NOTICE TO APPLICANTS ADDENDUM NO. One (1)

Grayton Beach State Park Campground Reinvestment DEP Bid NO. BDC33-17/18

- BASE BID UTILITY PAD DETAIL.
- Pre-Bid Meeting Sign In Sheet

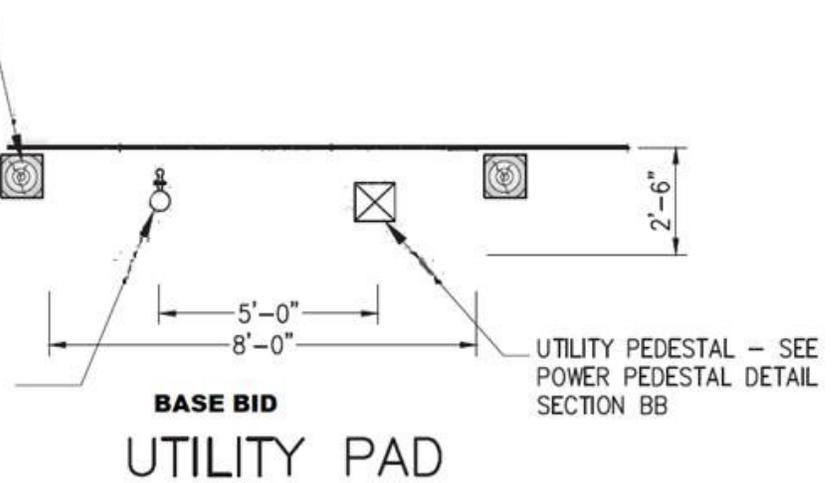
Response: Gravel road to be returned to the original condition.
6. **Question:** Will all campsites have 6x6 curb around the perimeter of camp site?
Response: See attached BASE BID UTILITY PAD DETAIL.

6"x 6" PT WOOD BOLLARD
ON ENTRY SIDE. INSTALL
SECOND BOLLARD ONLY AT
PULL THROUGH SITES

WATER SUPPLY STAND
PIPE W/ HOSE BIBB -
SEE HOSE BIBB DETAIL
SECTION AA

UTILITY PEDESTAL - SEE
POWER PEDESTAL DETAIL
SECTION BB
